MONITORING YEAR 5 ANNUAL REPORT

NORKETT BRANCH STREAM MITIGATION SITE

Union County, NC
DEQ Contract 004673
DMS Project Number 95360

RE: Norkett Branch Stream Mitigation Site-Year 5 Monitoring Report
Final Submittal for DMS
Contract Number 004673, RFP Number 16-004110, DMS# 95360
Yadkin River Basin – CU# 03040105; Union County, NC

Figure 3.4 Integrated Current Condition Plan View (Sheet 4 of 6)
 Norkett Branch Stream Mitigation Site
 DMS Project No. 95360
 Monitoring Year 5 - 2018
 Union County, NC

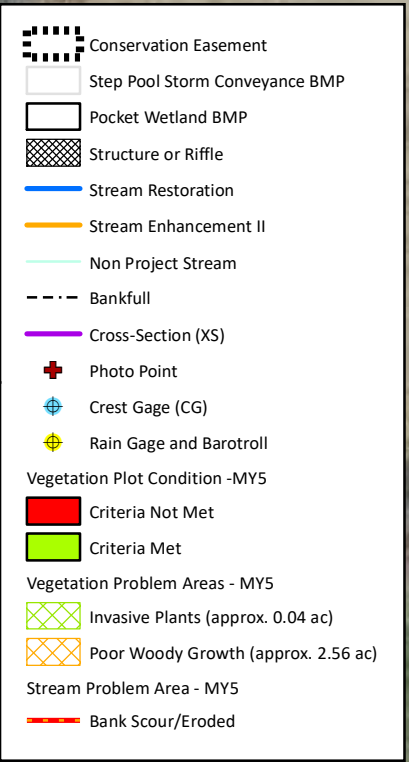
DMS Comment; CCPV – The photo point labels on Sheet 4 were inadvertently not shown in the draft. Please update for final.

Wildlands Response; The photo point labels have been added to Sheet 4..

Recorded Bankfull Events

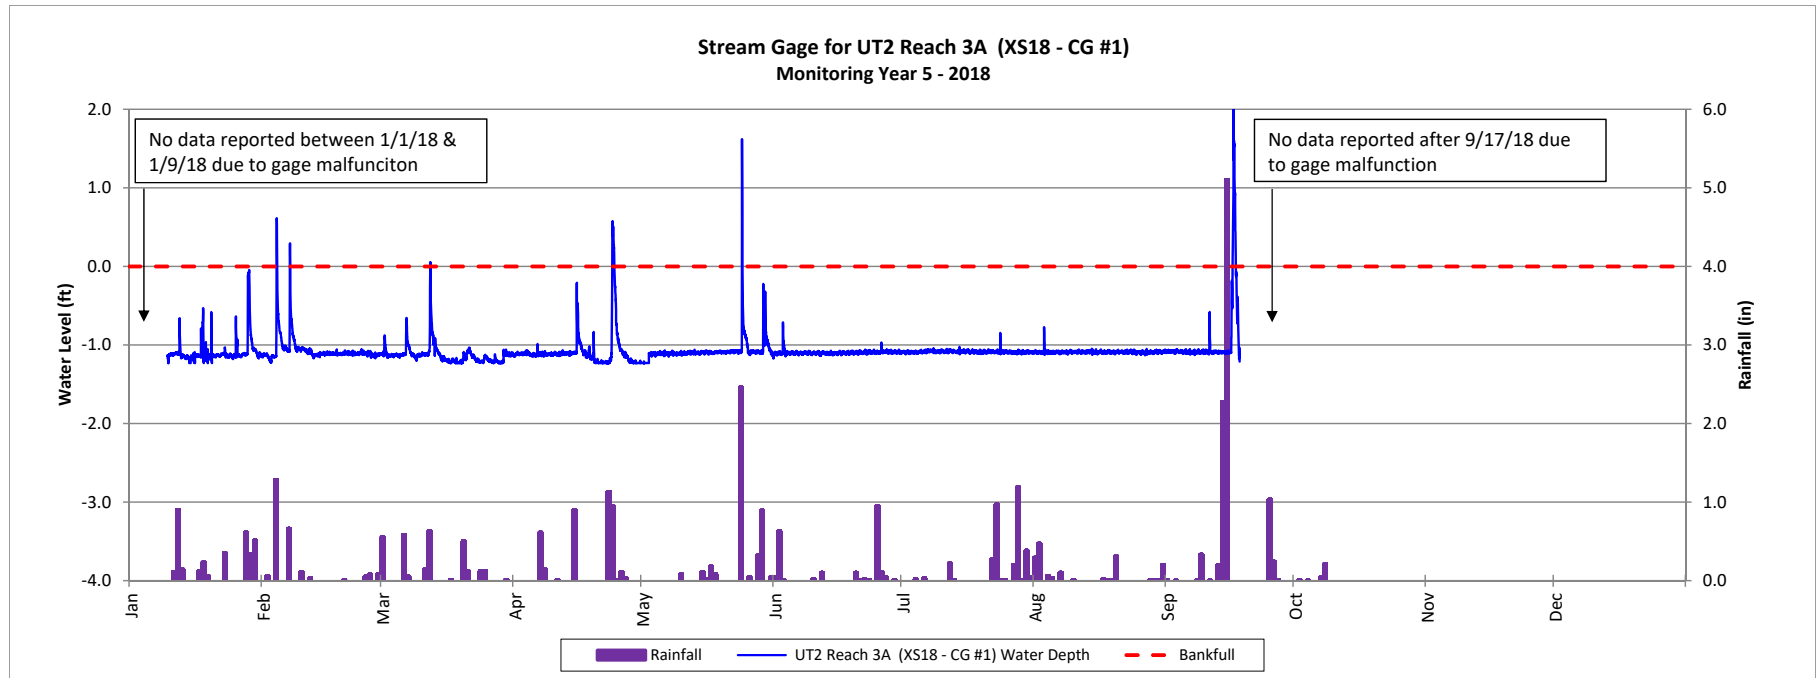
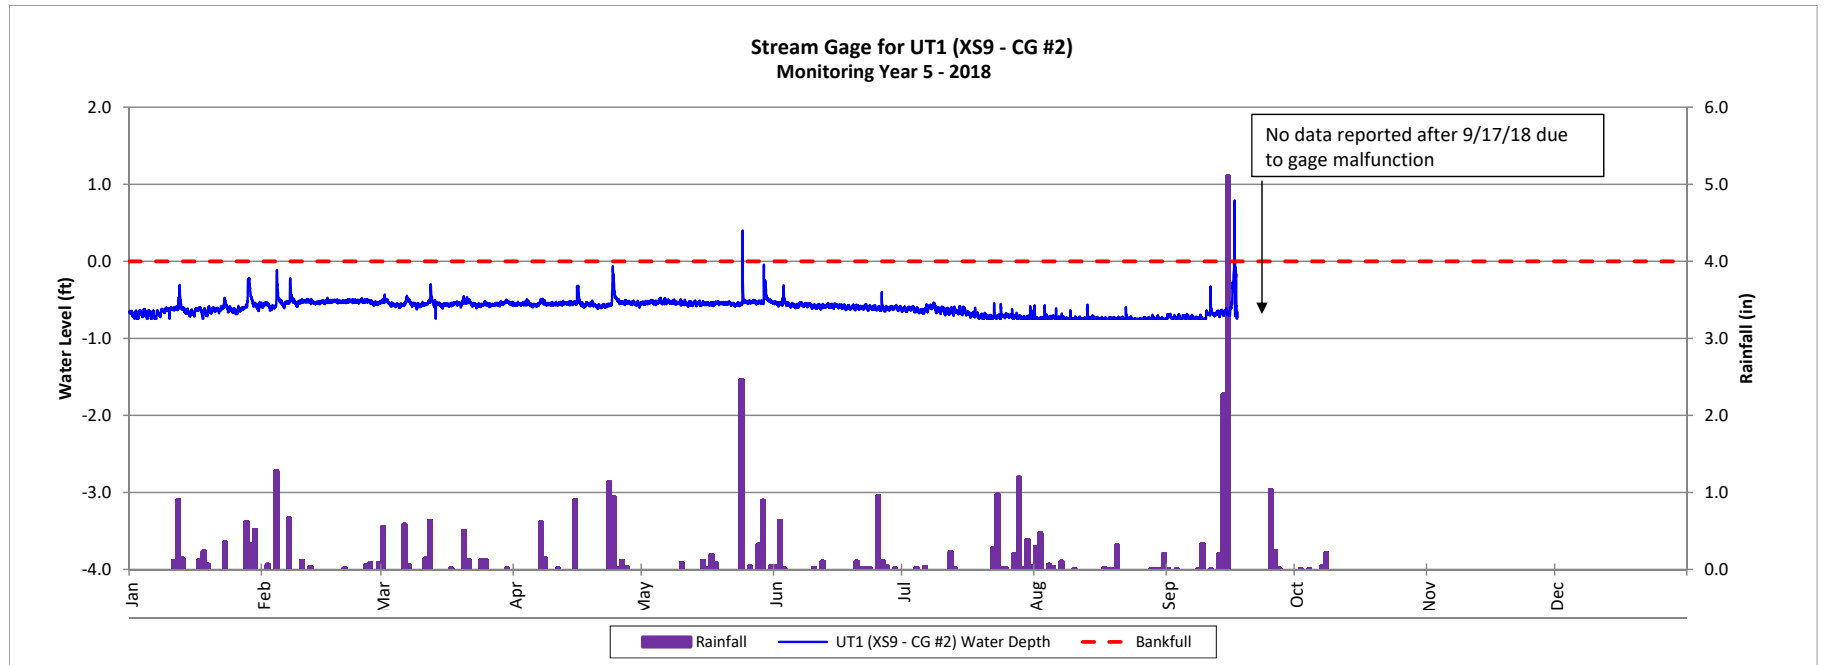
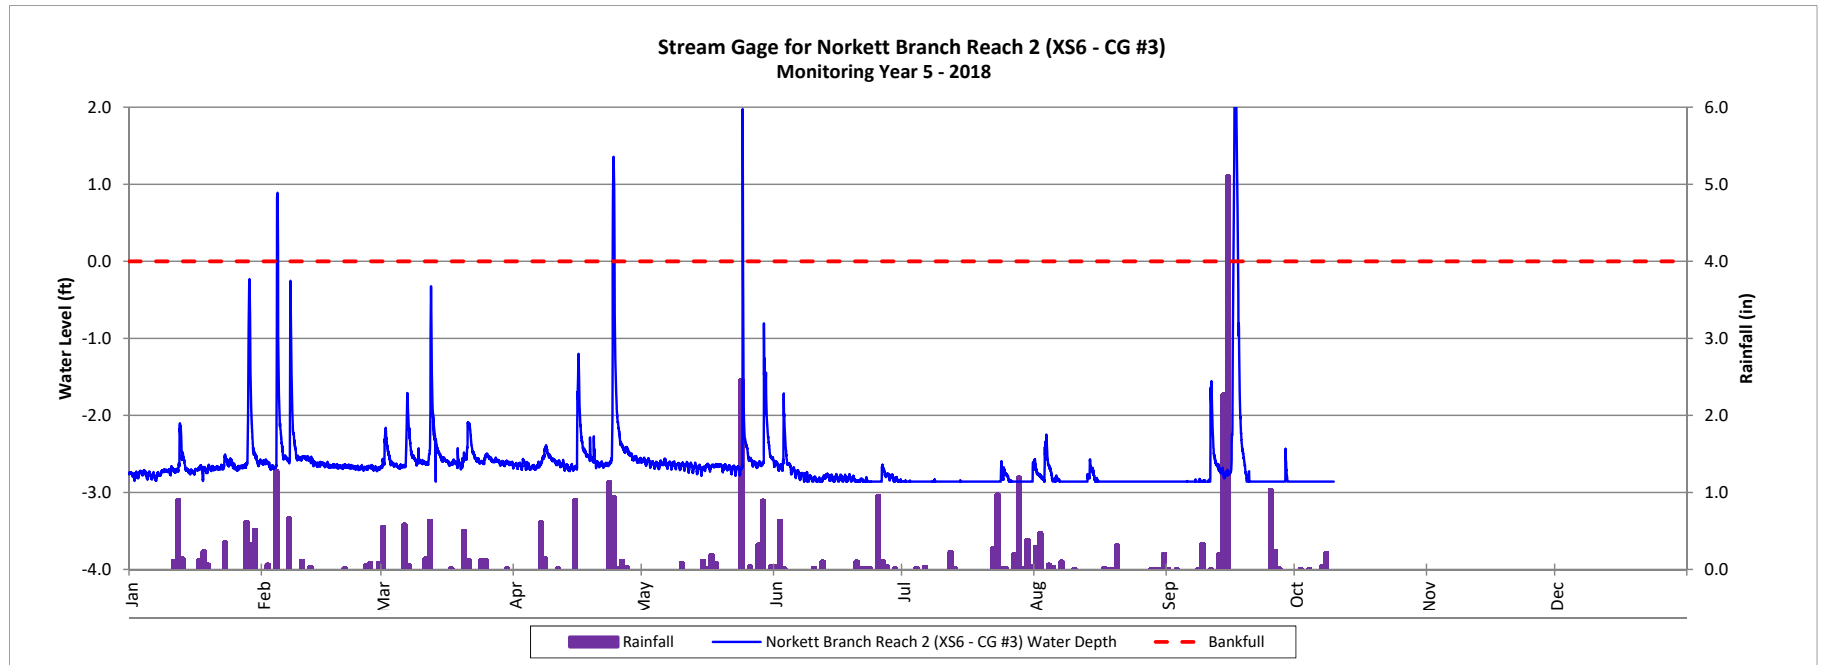
DMS Comment; Appendix 5 – Please include the stream flow gage data plots like previous monitoring years.

Wildlands Response; Stream flow gage data plots have been included in the final report.
